BMW Motorrad USA

Service Information Bulletin

Subject: Side Stand

Model: C 600 Sport (K18, 0132), C 650 GT (K19, 0134)

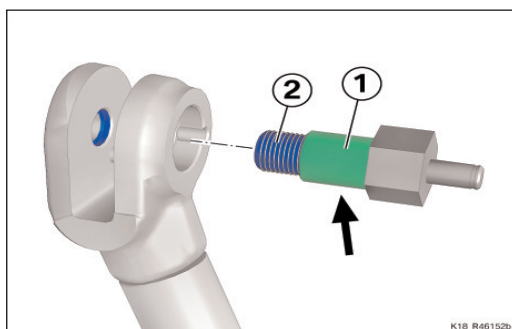
Details: BMW Motorrad has ascertained that in some cases the threaded fastener of the side stand can work loose. If this remains unnoticed by the rider, the consequence is that the side-stand switch is not tripped when the side stand is extended or retracted. There is a possibility of the engine refusing to start.

Aftersales Solution: Before handing over a new vehicle to its owner or when vehicles possibly affected by this problem are next brought to the workshop, secure the pivot bearing screw of the side stand with high-strength Loctite as described below. For details on removing and installing side stand, see work item 46 53 005 Removing/installing/cleaning/lubricating Side Stand in the latest RSD (Repair and Service Data BMW Motorrad).

Clean threads (arrows) of screw (1) and in side stand (2).

Cover threads (2) and lightly lubricate only the bearing face (arrow) of screw (1).

Lubricant	
Klüberplex BE 11-462 or an equivalent such as Staburags NBU 30 PTM	83 22 0 397 761 07 55 9 056 992

Apply thread-locking compound to thread (2).

Thread-locking compound	
Loctite 270, High strength	83 19 2 210 337
